**ADDENDUM #2
Town of Palisade
US 6 Palisade Sidewalk Project
TAP M021-001**

November 6, 2024

**PROJECT TITLE: US 6 Palisade Sidewalk
Town of Palisade Project**

US 6 PALISADE SIDEWALK PLAN AND PROFILE			
Designer:	LMV	Structure Numbers	
Detailer:	LAJ	Subset Sheets:	01 of 02
Sheet Subset:	PLN & PRF

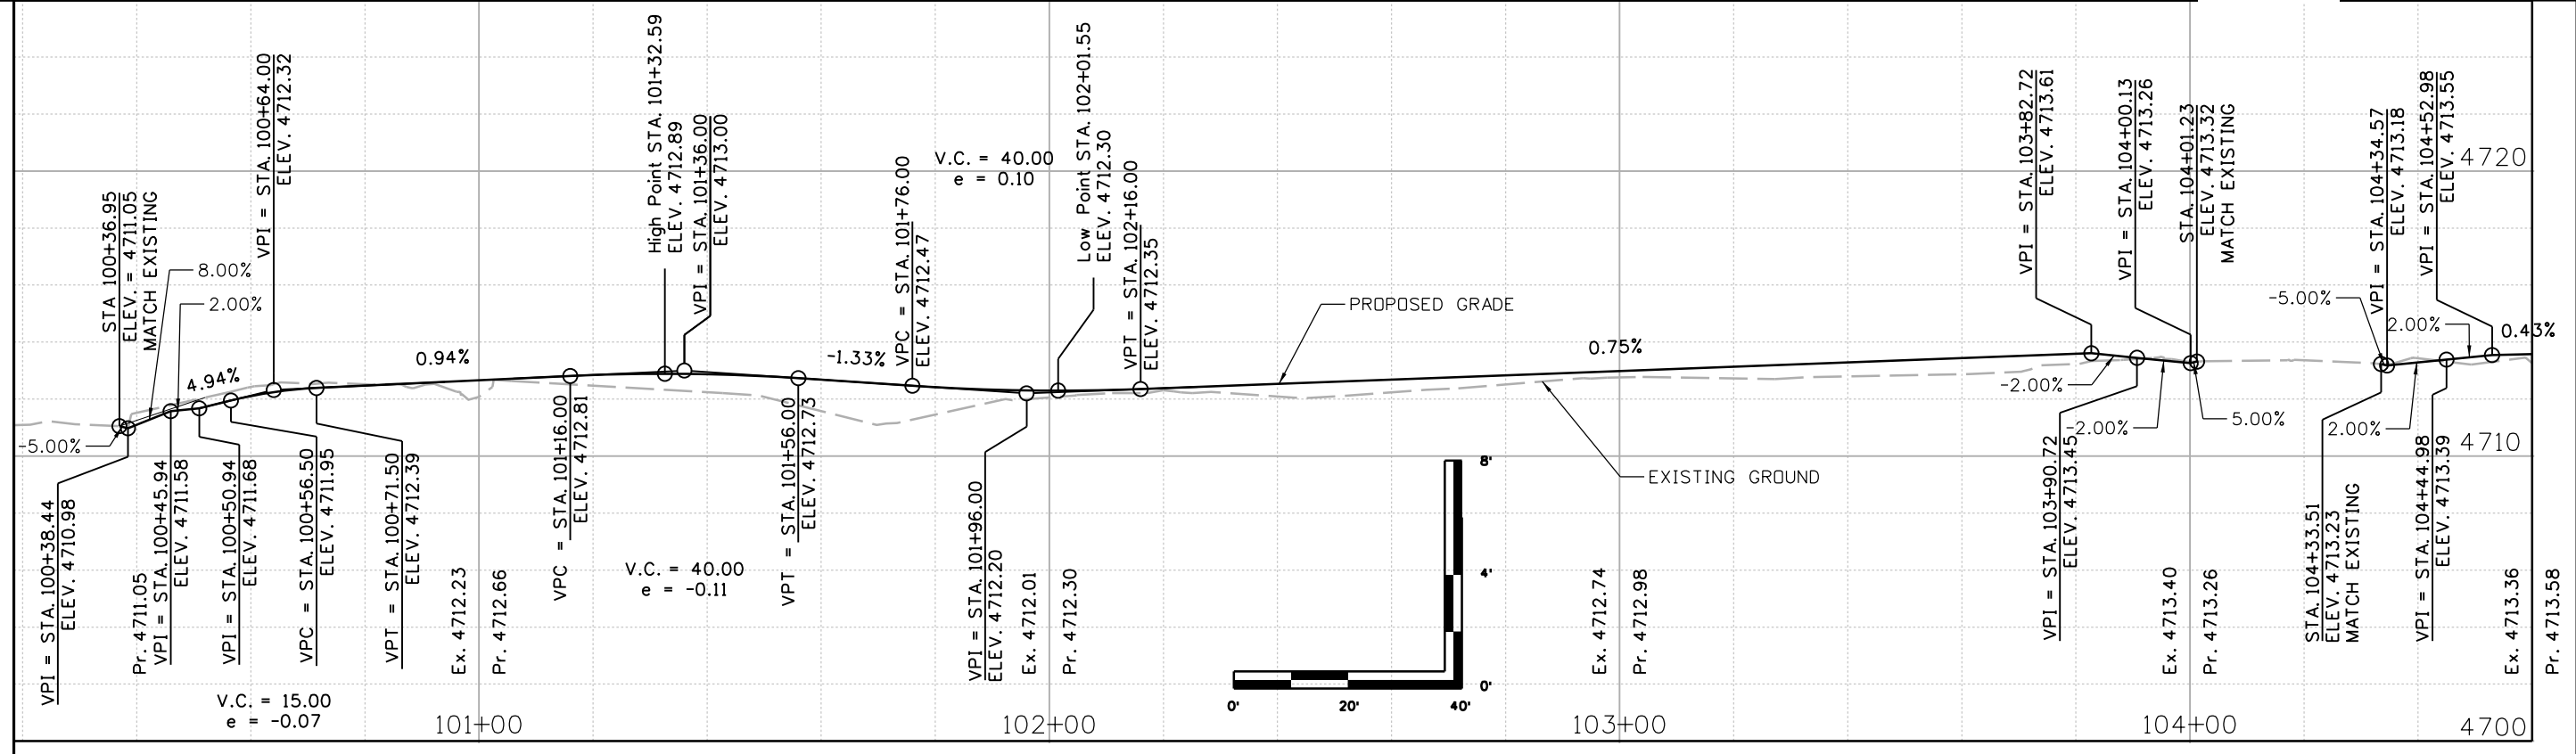
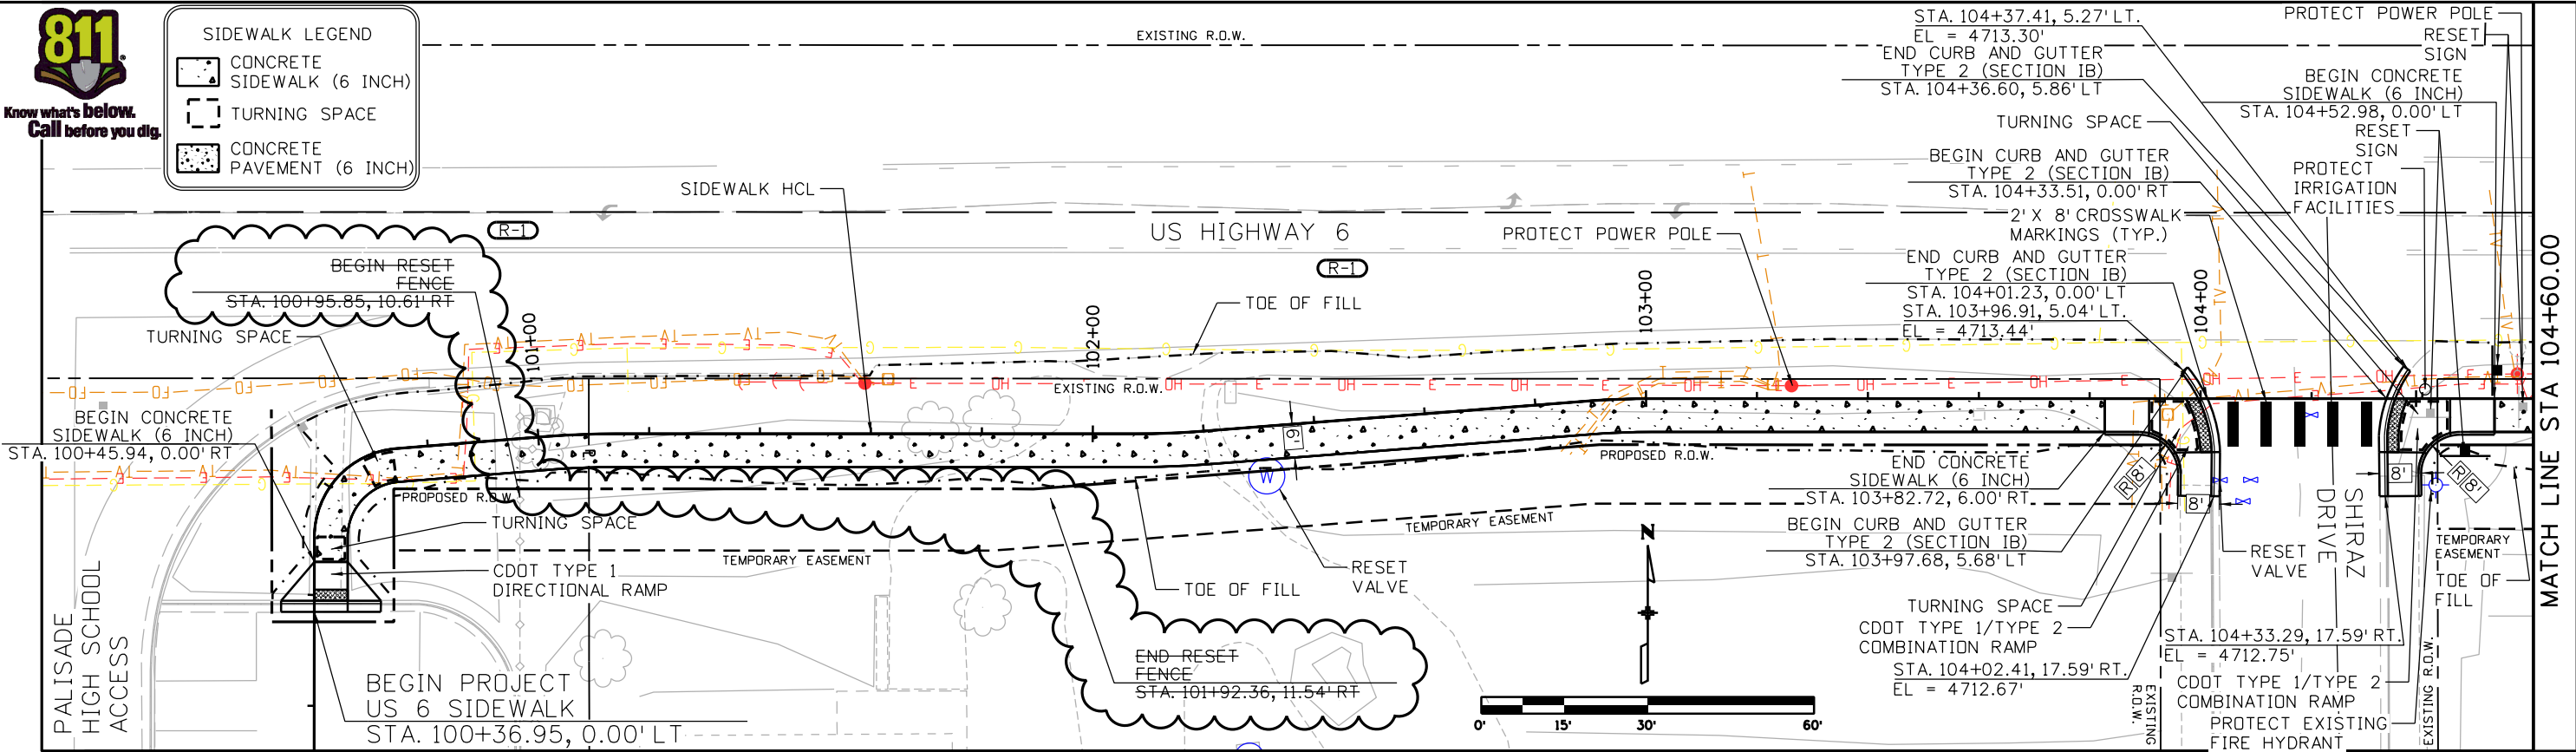
1. See the attached revised bid schedule that reflects the changes regarding the removal of the fence reset item, the inclusion of a fence removal item and the correction to curb and gutter type.
2. See the attached revised plan sheets reflecting the changes to the fence and curb and gutter items.
3. See the attached sign-in sheet from the Pre-Bid Meeting

Sheet Revisions		
Date:	Comments	Init.
11-6-24	Fence and Curb Updates	LAJ

US 6 PALISADE SIDEWALK PLAN AND PROFILE			
Designer:	LMV	Structure Numbers	
Detailer:	LAJ	Subset Sheets:	02 of 02
Sheet Subset:	PLN & PRF

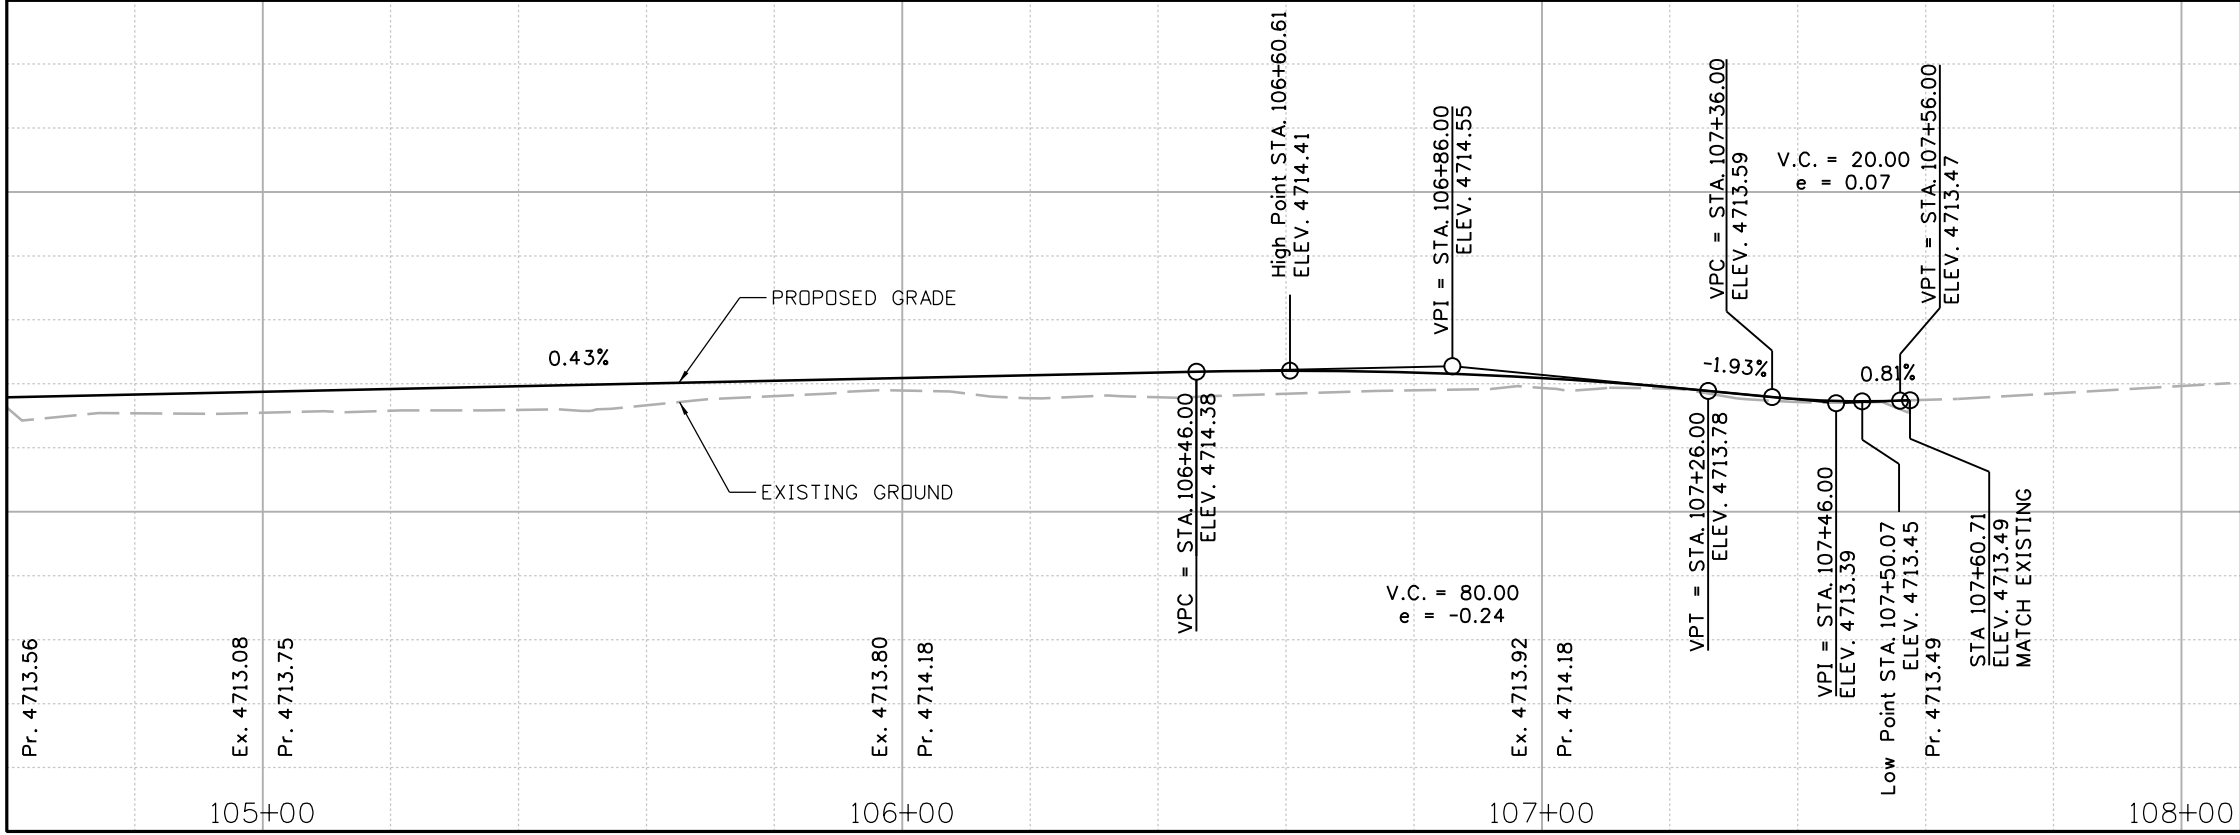
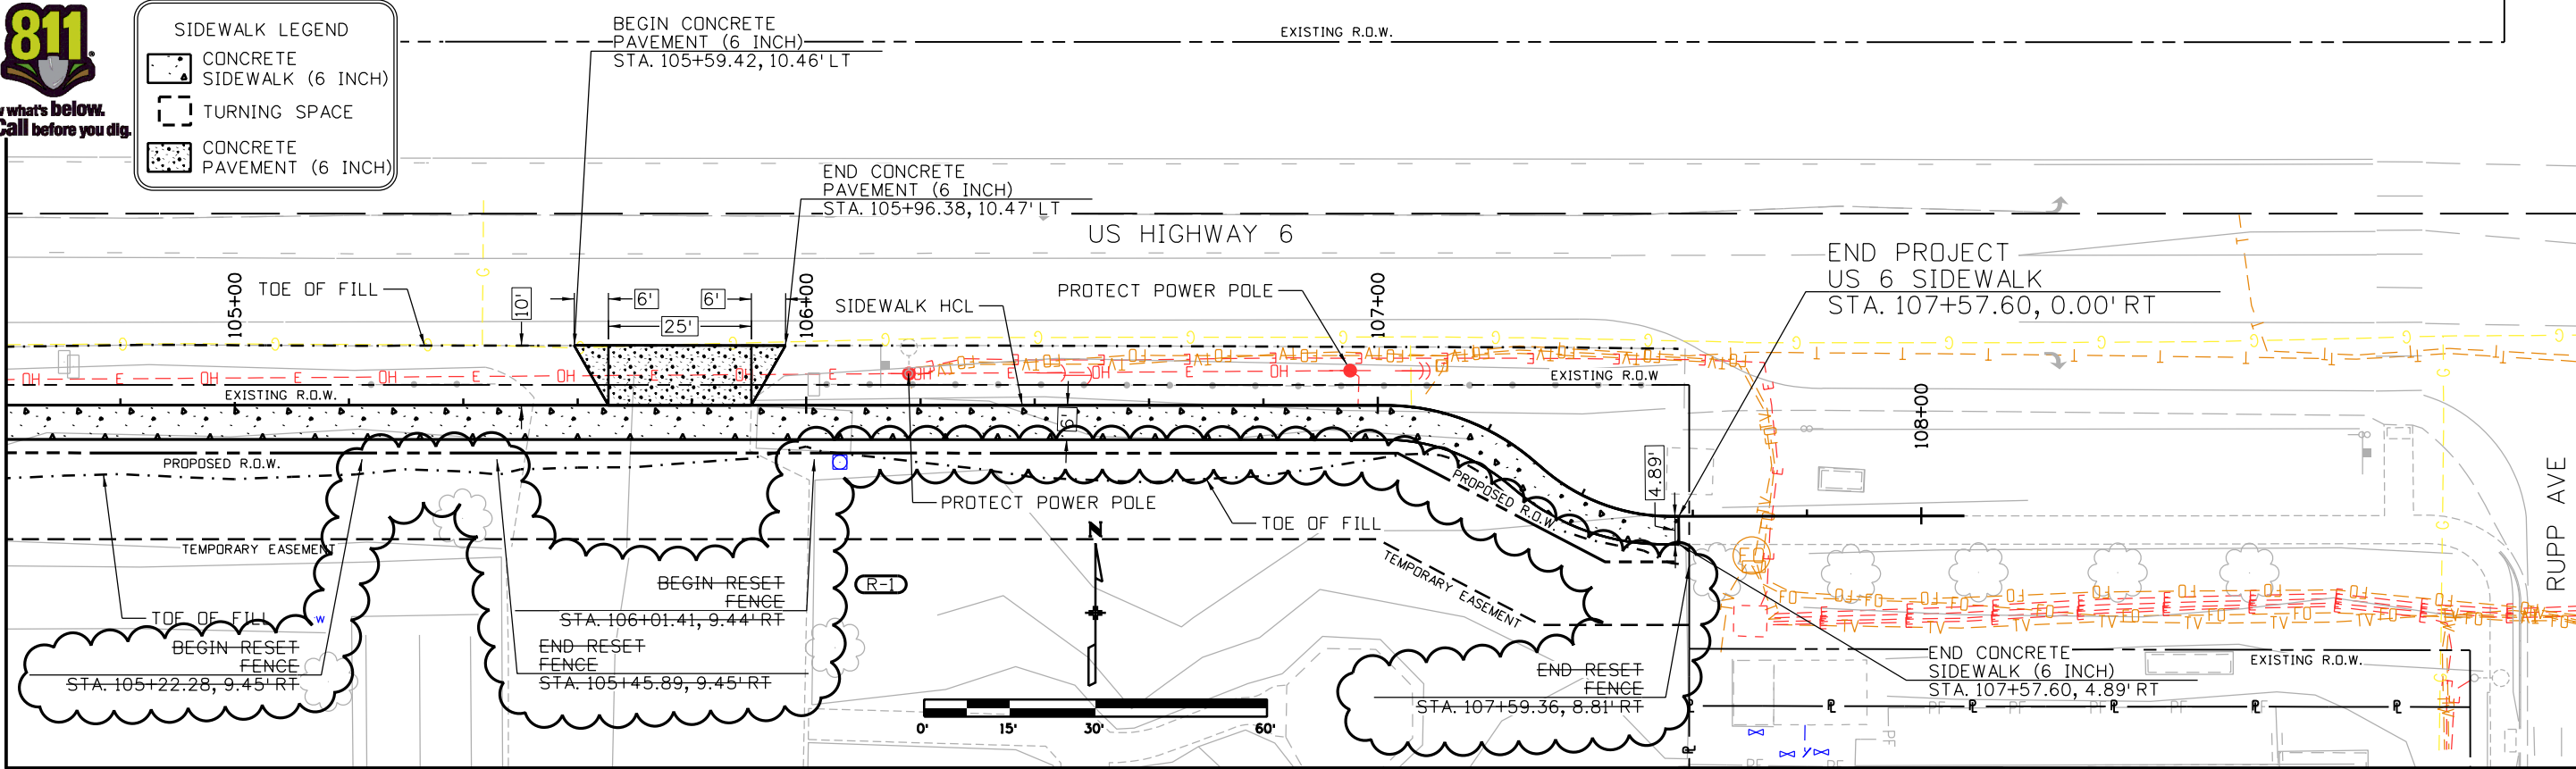
Sheet Revisions			
Date:	Comments	Init.	
11-6-24	Fence and Curb Updates	LAJ
